Inverter-Based Resource Performance Requirements

Interconnection Process Working Group (IPWG)

August 8, 2023

MISO adopted stakeholder feedback for *enter service* criteria and performance as defined by IEEE 2800

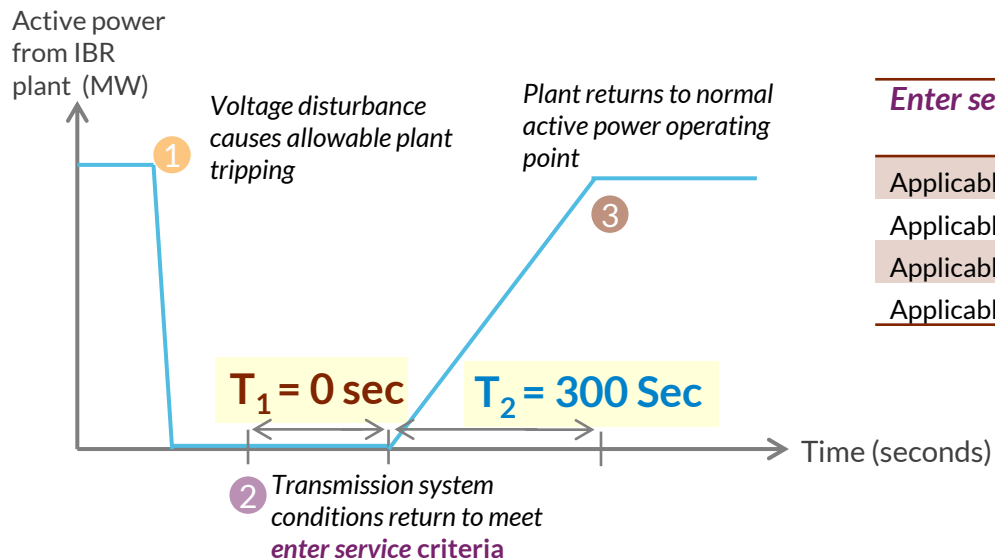
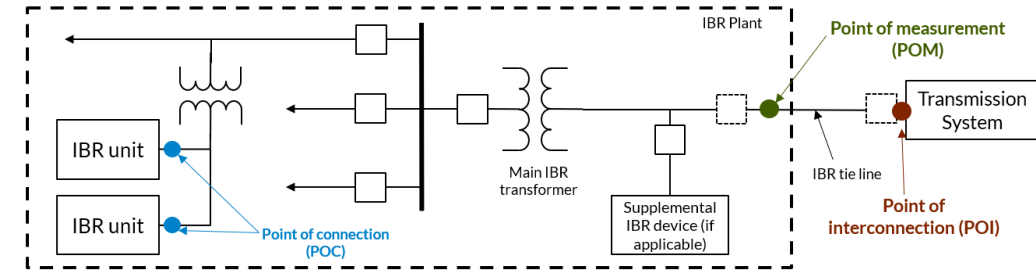
The Transmission Owner sector offered default values for Enter Service Performance (i.e., T_1 , T_2) which, given no other stakeholder opposition, were adopted by MISO

- Stakeholders shared various perspectives on the MISO proposal.
- MISO considers further adjustments to be most appropriate on a case-by-case basis.

<i>Enter service criteria</i>	Default Proposal	Range of allowable settings
Applicable voltage, minimum value	0.90 p.u.	0.9 p.u. to 0.95 p.u. ¹
Applicable voltage, maximum value	1.05 p.u.	1.05 p.u. to 1.10 p.u. ²
Applicable frequency, minimum value	58.8 Hz	58.8 Hz to 59.4 Hz
Applicable frequency, maximum value	60.12 Hz	60.12 Hz to 61.2 Hz

T_1 represents the **intentional adjustable minimum delay**, with a *range of allowable settings* from 0 s to 60 s.
 T_2 represents the **duration of *enter service* period**, with a *range of allowable settings* from 1 s to 1000 s.

MISO views the RPA at POI selection as the best reliability-supporting selection

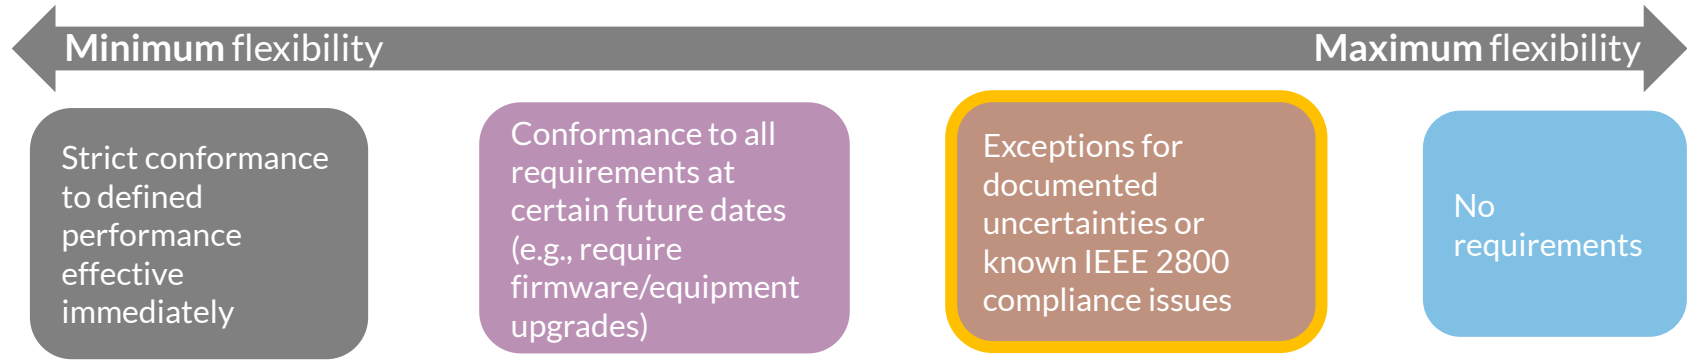
- Stakeholder feedback was mixed on MISO's proposal for the RPA to be at the POI.
- Some stakeholder feedback was based on current application of NERC standards, though MISO views the specific standard language as requiring flexibility.

- PRC -024-3: "When evaluating protection settings, consider the voltage differences between where the protection is measuring voltage and the high side of the GSU/MPT."

- VAR-002-4.1: "Generator Operators that do not monitor the voltage at the location specified in their voltage schedule shall have a methodology for converting the scheduled voltage..."

- FERC has established precedent for performance requirements at the POI
 - FERC SGIA (RM16-1-000): "to design its generating facility to maintain a composite power delivery at continuous rated power output at the Point of Interconnection at a power factor¹ of 0.95 leading to 0.95 lagging, or a different range if adopted by the Transmission Provider..."

- MISO understands potential POI substation implications and is requesting additional feedback
